COMMENTS - OU5 FS/PP

OEPA DOE-FN
100
COMMENTS

RE: DOE FEMP
MSL #531-0297
HAMILTON COUNTY
COMMENTS -
OU5 FS/PP

**OHIO EPA COMMENTS
ON THE
OPERABLE UNIT 5 FS/PP**

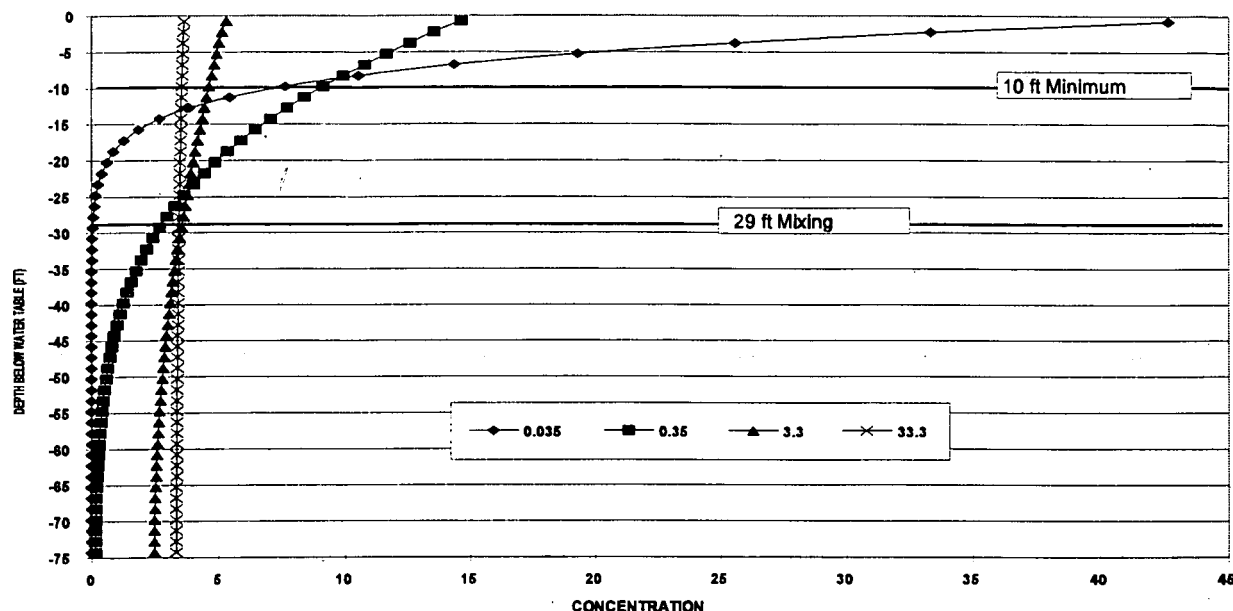
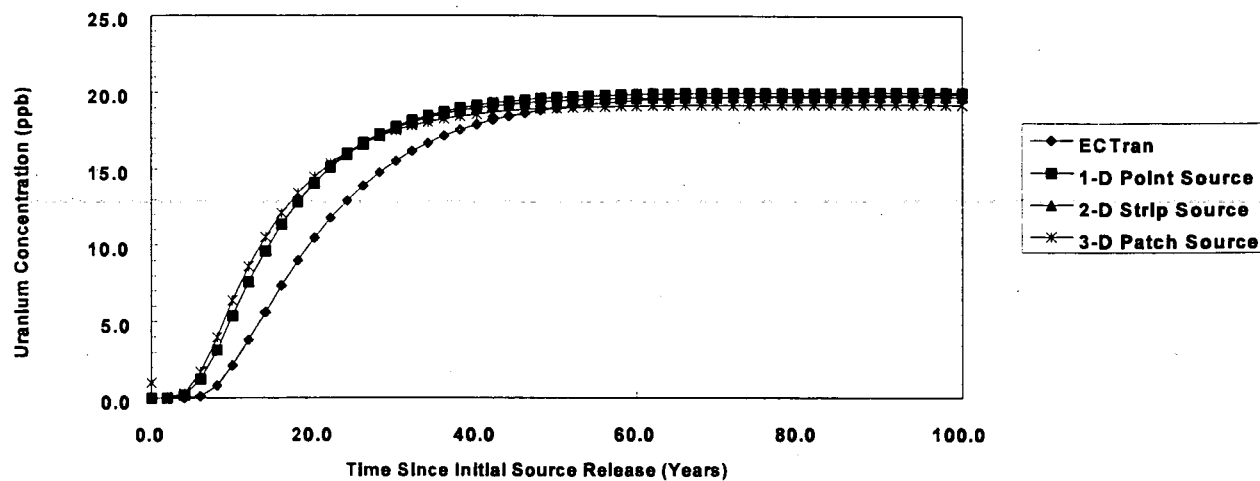
Comment: Justification for selecting different mixing depths is needed. The ECTran model calculates the mixing depth as a function of the ratio of vertical and horizontal fluxes and the vertical dispersivity (Equation 8, p. 3-10 in ECTran Sept 1993 documentation). The mixing depth is dominated by the latter term in which a vertical dispersivity of 0.35 feet results in a calculated mixing depth of 26.45 feet.

In order to better understand the importance of the magnitude of the vertical dispersivity and analyze the approximation of the mixing depth relation, we constructed a numerical model. A two-dimensional vertical section of the saturated GMA, extending 1000 by 75 feet was simulated using SWIFT. Small grid blocks were assigned to represent the mixing directly beneath the disposal area. A grid 40 columns by 50 rows with a cell size of 25.0 by 1.5 feet was constructed. A horizontal flow rate of 304 ft/year was imposed using constant heads. The longitudinal dispersivity assigned was 100 feet and four values of transverse dispersivity were simulated. Contaminant transport was simulated to steady-state. Concentration profiles along the downgradient edge of the landfill were plotted as shown below:

These simulations show (for the system modeled using SWIFT) the relationship between transverse dispersivity and mixing depth. The higher dispersivity values produce unrealistically deep mixing depths. The dispersivities and calculated mixing depths used in the ECTran simulations are within the reasonable range of results simulated using SWIFT. Because the contaminants are generally limited to the 2000 and 3000 series wells, it is reasonable to assume that the vertical dispersivity is small and probably less than 1 foot.
